| Project | IEEE 802.16 Broadband Wireless Access Working Group < http://ieee802.org/16 > | |
| Title | HARQ Through RS UL Dedicated Channel | |
| Re: | IEEE P802.16j/D1: IEEE 802.16j working group letter ballot #28. | |
| Purpose | To incorporate the proposed text into the P802.16j Baseline Document IEEE P802.16j/D1 (August 2007). | |

Figure XXX – UL DCH control header

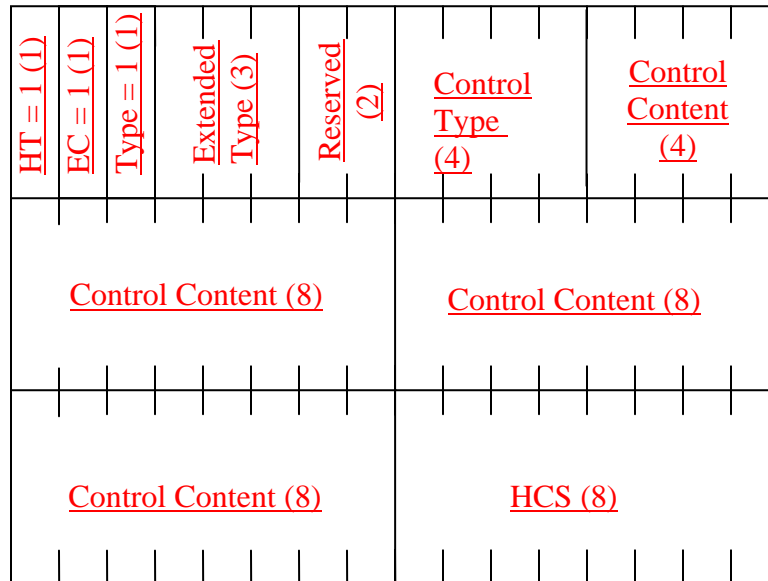
6.3.2.1.2.2.2.7 UL DCH control header

The UL DCH control header is used by the RS to send control signaling to MR-BS or superordinate RS. The header format is as follows:
